Remarks Section  
Application #10/667, 634  
Filing Date: 9/22/2003  
Re: Claims

**"Annotated Sheet"****Drawings****Dermaewear: "Modified Men's Briefs"**

Application #10/667, 634

Figure 3C

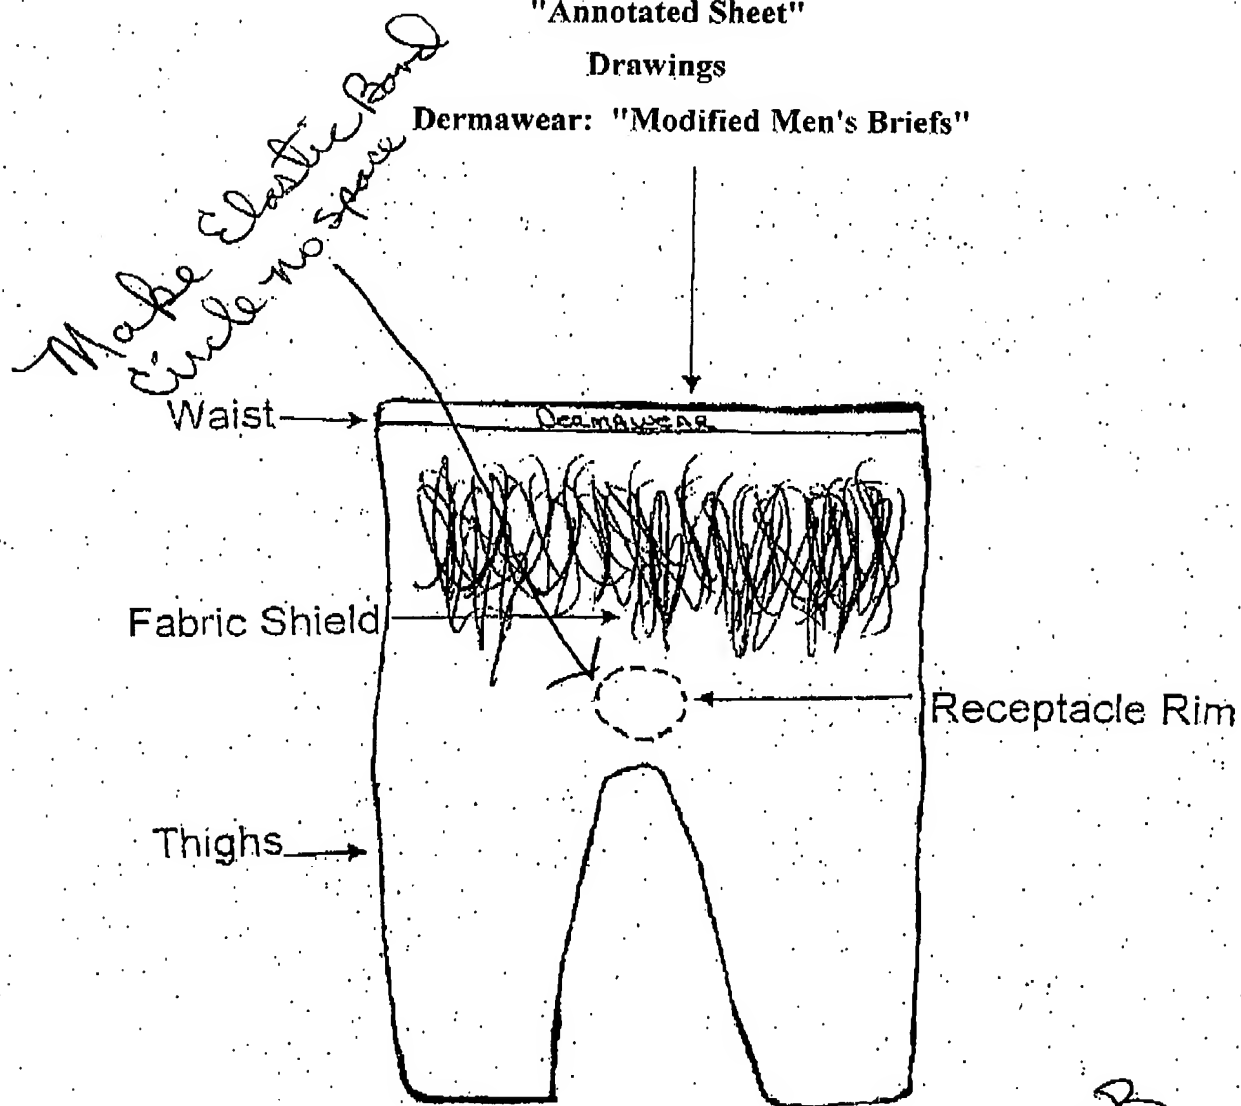
*Other Borders will not ~~work~~ work.*

*Figure 3C not needed for Dermaewear*

Note: 3C is no longer a part of the drawings. Again, the drawings are the same since the original filing date through present. Even though the loop defense strands were in fact illustrated on the "Replacement Sheets" and mistakenly omitted on the original drawings.

~~Figure B2~~

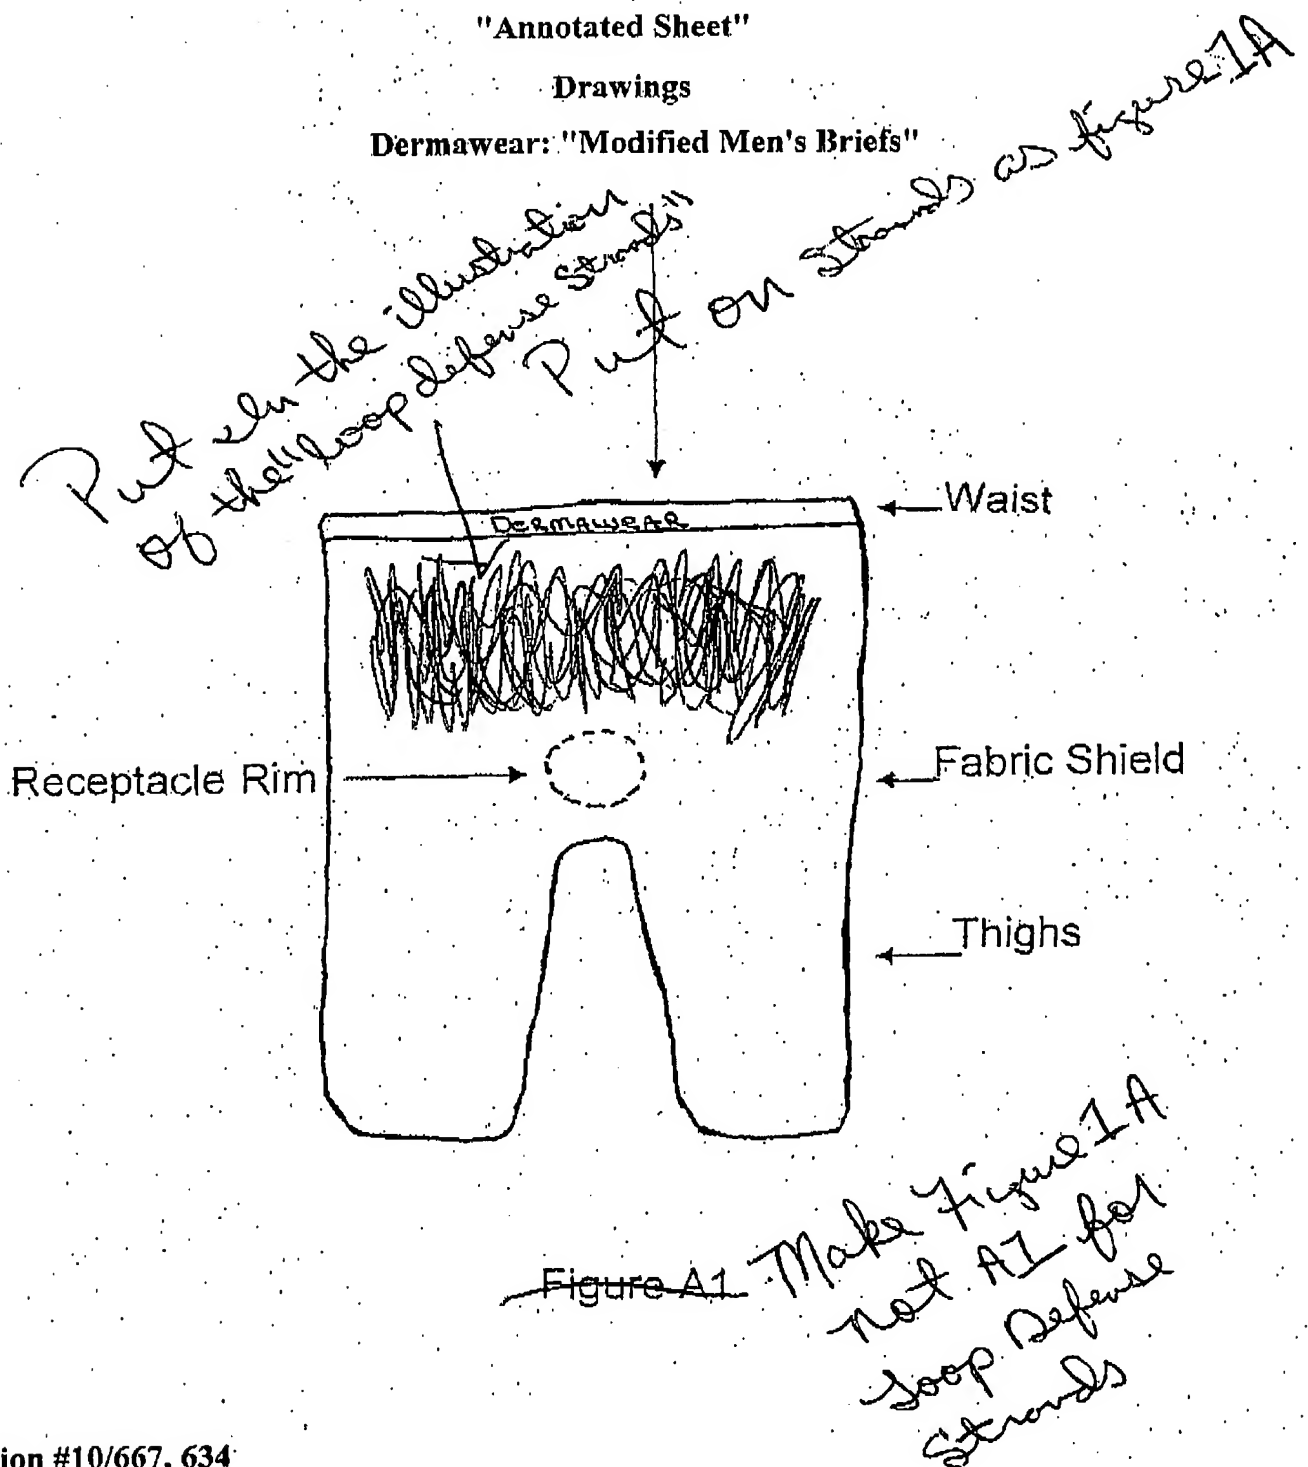
*Make Figure 2B  
not B2*
